# **Variable Coded Modulation Red Book**

## **C&S WG Response to CESG Poll**

November 8, 2017

# Pilot Tones – VCM Red Book

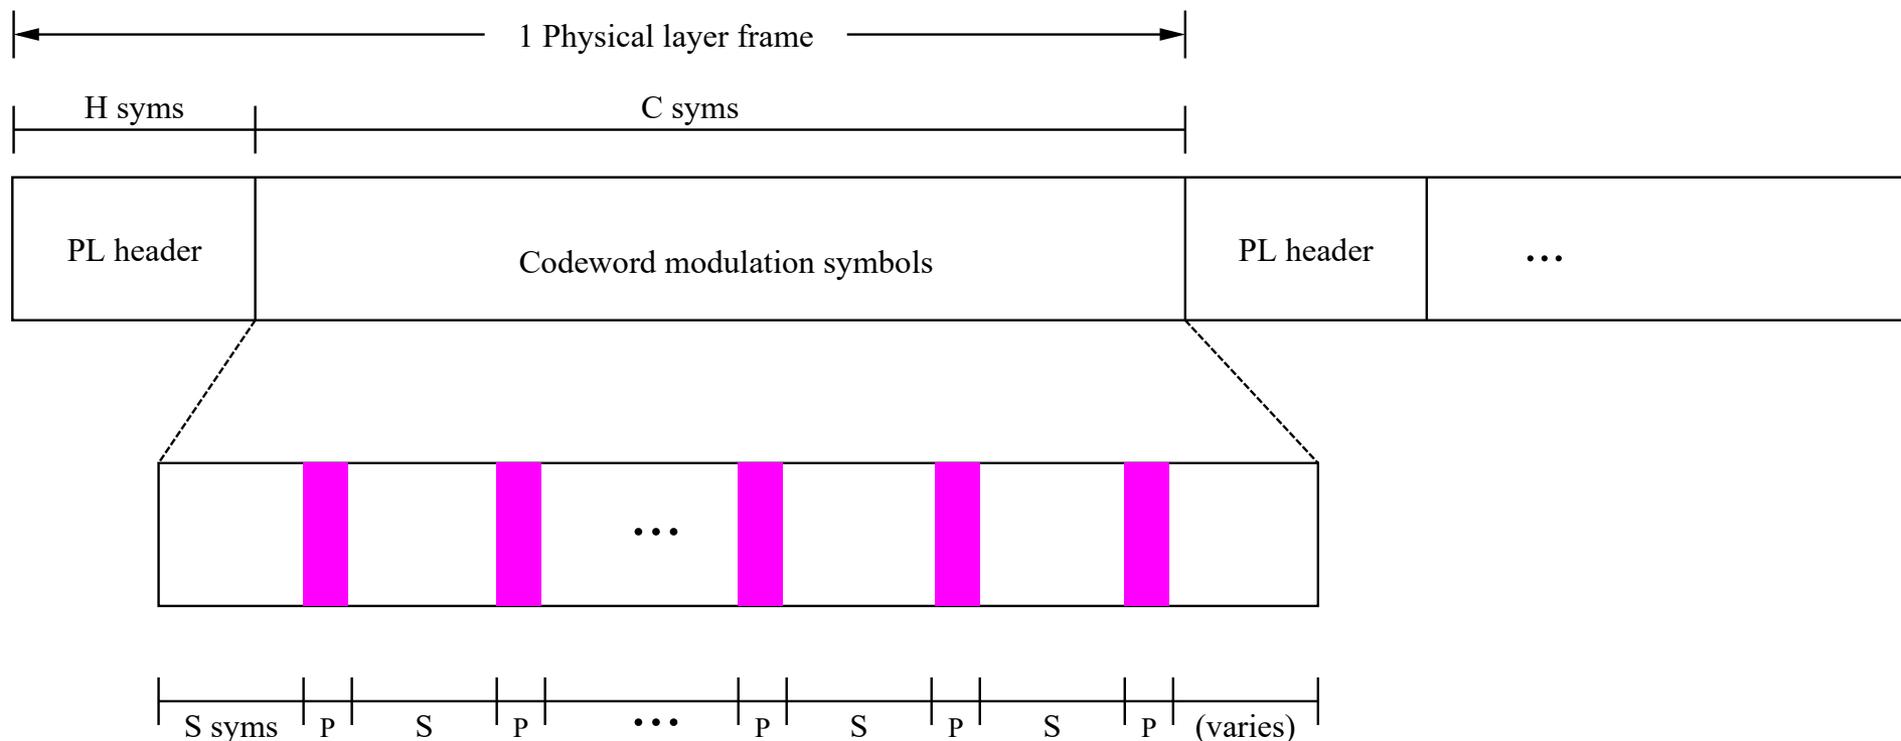
2) The explicit definitions of pilots appears ambiguous (pg 3-1)

- Context: “[3.1] ... and optionally inserting pilot symbols...”

Comment: “Since the use of this approach with standard CCSDS coding and synch is the whole point of this, this statement seems suspect. What more work is needed to fully specify the pilot symbols for [1]?”

Response: Accepted. Section 3.2.1.6 and Figure 3-2 have been added to clarify the insertion of pilot symbols.

Response: Accepted. Section 3.2.1.6, along with Figure 3-2 have been added to clarify the pilot symbol insertion. No additional work is needed to fully specify the pilot symbols.

How pilot symbols are inserted:

- P pilot symbols are inserted after every S codeword symbols
- The physical layer header is H symbols; the physical layer frame payload is C symbols
- C may or may not be a multiple of S
